Access Compliance Report

Public Rights-of-Way

Intersection ID: 10026441	Main Street: FARMHURST_DR	Cross Street: N/A	Location: NE
ADA ID: 8ADD80A8D3EE	Ramp Type: BlendTrans2	Initial Pass/Fail: Fail	Overall Compliance: No
		Severity Score: 25

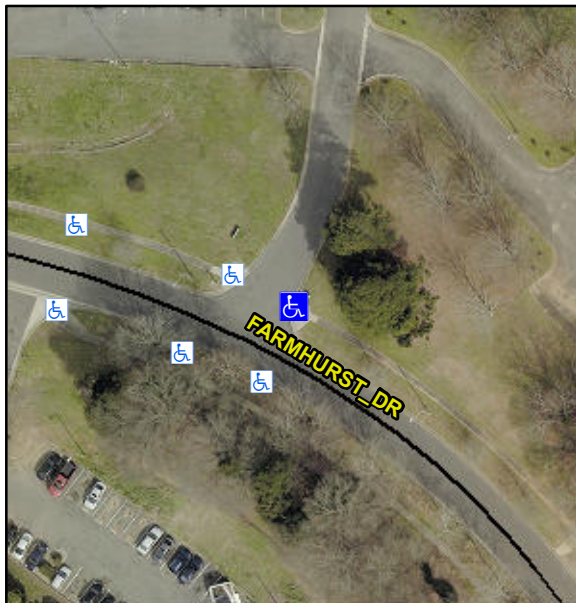
Not Found, R304.5.3

Compliance	Description	Data	Compliance	Description	Data
N/A	Ramp Length (in)	92.0	Yes	BlendTrans Slope (%)	0.8
Yes	Ramp Width (in)	50.0	No	BlendTrans XSlope (%)	8.1
N/A	Flare Type LT	N/A	N/A	Flare Type RT	N/A
N/A	Flare Slope LT (%)	N/A	N/A	Flare Slope RT (%)	N/A
N/A	Flare Traversable LT?	N/A	N/A	Flare Traversable RT?	N/A
N/A	Landing Length (in)	N/A	N/A	DWS Provided?	N/A
N/A	Landing Width (in)	N/A	N/A	DWS Contrast?	N/A
N/A	Landing Slope (%)	N/A	N/A	DWS Length (in)	N/A
N/A	Landing X Slope (%)	N/A	N/A	DWS Full Width?	N/A
N/A	Landing Curb? (Y/N)	N/A	N/A	DWS Offset (in)	N/A
N/A	Shared Landing?	N/A			
N/A	Gutter Ponding?	N/A	N/A	Gutter Slope (%)	N/A
N/A	Gutter Lip Ht (in)	N/A	N/A	Gutter X Slope (%)	N/A
N/A	Painted X Walk1?	No	N/A	Painted X Walk2?	No
	X Walk 1 Direction	To NW		X Walk 2 Direction	To SW
	X Walk 1 Width (in)	N/A		X Walk 2 Width (in)	N/A
	X Walk 1 Slope (%)	1.8		X Walk 2 Slope (%)	7.0
	X Walk 1 X Slope (%)	8.1		X Walk 2 X Slope (%)	3.7

N/A	Ramp inside XWalk1?	N/A	N/A	Ramp inside XWalk2?	N/A
	Road Slope (%)	8.5		Clear Space?	N/A
	Road X Slope (%)	0.4	N/A	Clear Space to XWalk (in)	N/A
N/A	Any Obstructions?	N/A	N/A	Storm Grate/Utility Hazard?	N/A
	Obstruction Type			Storm Grate/Utility Type	
		N/A			N/A
			Yes	Surface Condition? (G/P)	Good
			No	Curb Slope (%)	16.3

Remove & Replace Curb Ramp With Two New Directional Ramps or Equivalent.
